Thank you for helping me to submit a revised draft of my manuscript titled **Characteristics of debris flows recorded in the Shenmu area of central Taiwan between 2004 and 2021** to *Natural Hazards and Earth System Sciences*. I appreciate the time and effort that you and the reviewers have dedicated to providing your valuable feedback on my manuscript. I am grateful to the reviewer's insightful comments on my paper. I have been able to incorporate changes to reflect most of the suggestions provided by the reviewers. I have highlighted the changes within the manuscript. After the revision, I believe that this study and its outcomes fulfil the scope of journal.

### **Comments from Reviewer RC1**

Fig. 1.

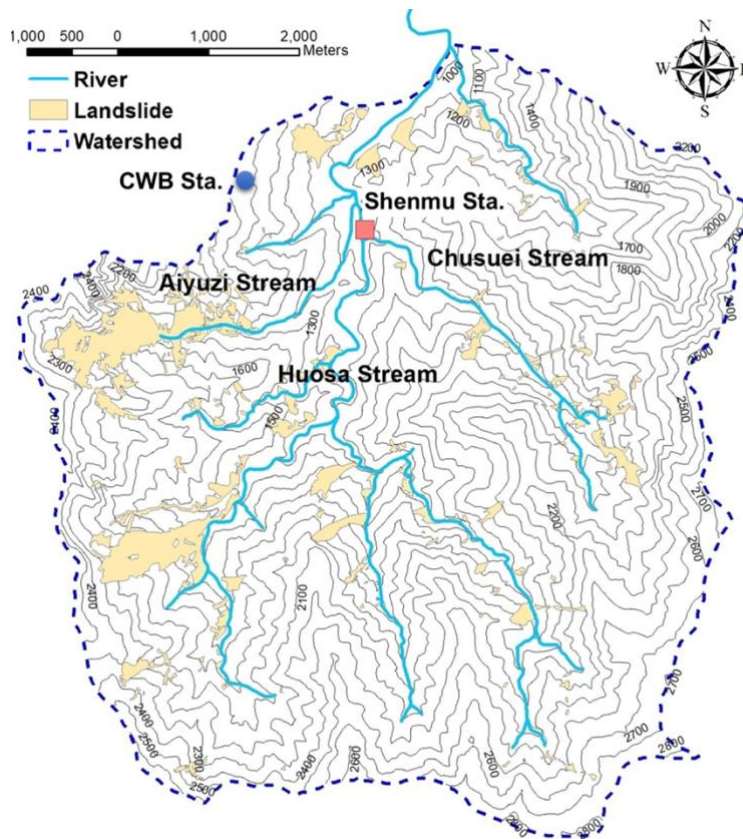
- **Comment 3:** *Some names are different in Figure 1 and Figure 2.*

- **Comment 3:** *Line 42-45: two important rainfall data resources were proposed here. Please address them in Fig.1 or 2.*

**Response:** Thank you for your suggestion. The name of Shenmu Sta. is corrected in Figure 1, and the name of Chusuei Stream is corrected in Figure 2.

**Response:** Thank you for your suggestion. The rainfall stations are added and marked on Figure 1.
